June 13, 2005

RE: Exception to Statewide Rule 107(J)
Bravo Dome Carbon Dioxide Gas Unit
Harding/Union County, New Mexico

**Exception SWR 107(J) - Proposed
OXY USA Inc.
Bravo Dome Carbon Dioxide Gas Unit**

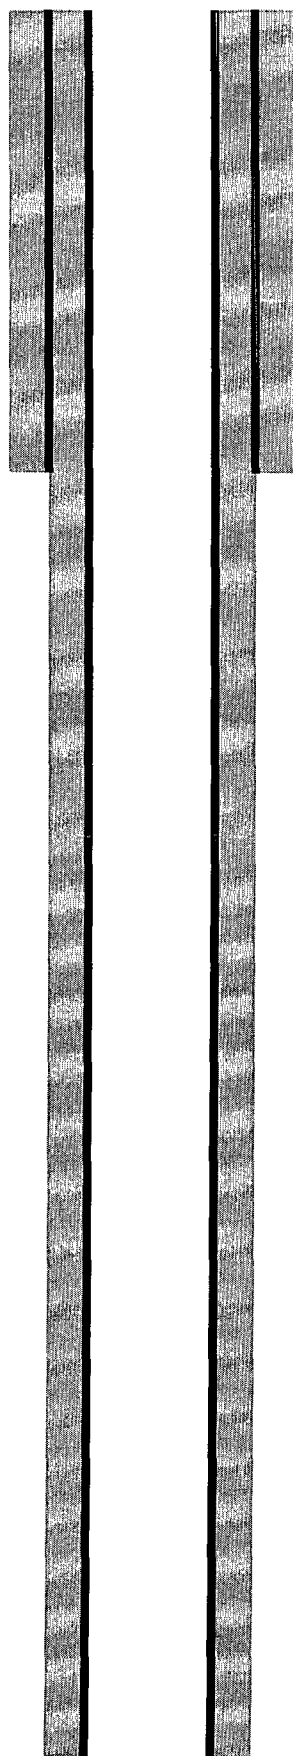
This is OK with me,
Roy

OXY USA Inc. respectfully requests a blanket exception to SWR 107 (J), in order to drill and complete our wells in the Bravo Dome Carbon Dioxide Gas Unit. On the wells where this exception would pertain, OXY plans to run 5-1/2" 5.3# fiberglass through the Cimarron and 15.5# J55 LTC steel casing through the Tubb to TD. OXY will produce the well through the production casing in lieu of producing through the tubing. In support of our request, the following reasons exist.

NO WASTE caused
19, 15, 3, 107 J. (4)

For the reason's outlined in your letter and because waste will not be caused, you are hereby authorized to produce your CO2 gas wells up the casing without installing tubing. This approval is contingent on such wells being completed with steel casing across the Tubb formation and fiberglass casing from the Tubb to the surface.
